Access Compliance Report

Public Rights-of-Way

(Curb Ramps)

Intersection ID: 5056	Main Street: HEDGECREST_PL	Cross Street: HUBBARD_RD	Location: NW
ADA ID: E38FC2C26BD6	Ramp Type: PerpDiag	Initial Pass/Fail: Fail	Overall Compliance: No
Severity Score: 25			
Codes/Mitigation Info/Possible Solution		Field Measurements/Component Compliance

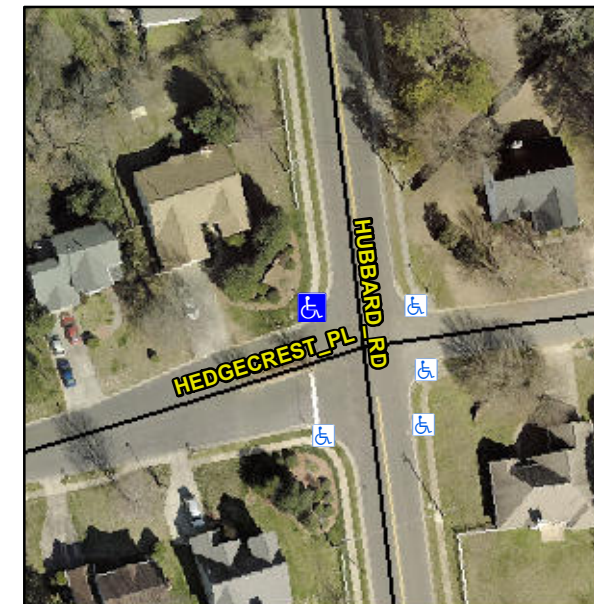
Not Found, R304.2.2

Compliance	Description	Data	Compliance	Description	Data
N/A	Ramp Length (in)	51.0	No	Ramp Slope (%)	15.6
Yes	Ramp Width (in)	48.0	Yes	Ramp XSlope (%)	1.4
N/A	Flare Type LT	N/A	N/A	Flare Type RT	N/A
N/A	Flare Slope LT (%)	N/A	N/A	Flare Slope RT (%)	N/A
N/A	Flare Traversable LT?	N/A	N/A	Flare Traversable RT?	N/A
N/A	Landing Length (in)	N/A	N/A	DWS Provided?	N/A
N/A	Landing Width (in)	N/A	N/A	DWS Contrast?	N/A
N/A	Landing Slope (%)	N/A	N/A	DWS Length (in)	N/A
N/A	Landing X Slope (%)	N/A	N/A	DWS Full Width?	N/A
N/A	Landing Curb? (Y/N)	N/A	N/A	DWS Offset (in)	N/A
N/A	Shared Landing?	N/A			
N/A	Gutter Ponding?	N/A	N/A	Gutter Slope (%)	N/A
N/A	Gutter Lip Ht (in)	N/A	N/A	Gutter X Slope (%)	N/A
N/A	Painted X Walk1?	No	N/A	Painted X Walk2?	No
	X Walk 1 Direction	To W		X Walk 2 Direction	To E
N/A	X Walk 1 Width (in)	N/A	N/A	X Walk 2 Width (in)	N/A
	X Walk 1 Slope (%)	0.9		X Walk 2 Slope (%)	4.4
	X Walk 1 X Slope (%)	3.6		X Walk 2 X Slope (%)	1.6

Remove & Replace Curb Ramp With Two New Directional Ramps or Equivalent.
